**POLK COUNTY, A POLITICAL SUBDIVISION OF
THE STATE OF FLORIDA**

**ADDENDUM # 3
BID # 26-041, Lakeland Hills EMS Station**

BID # 26-041, Lakeland Hills EMS Station

Addendum # 3

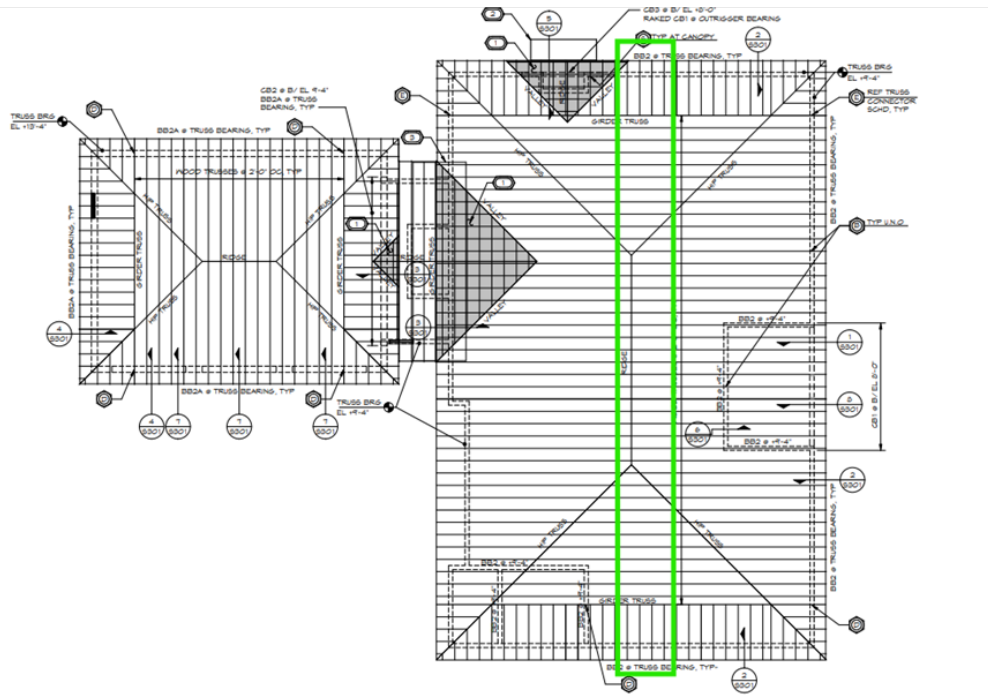
Q33: Ref. Page C5 and P201- Please clarify limits of civil sanitary and plumbing sanitary, as page C5 and P201 are in conflict.

A33: Both plumbing lines including the grease trap as shown on drawing sheet P201 are required. Civil contractor shall refer to drawing sheet P201 as necessary.
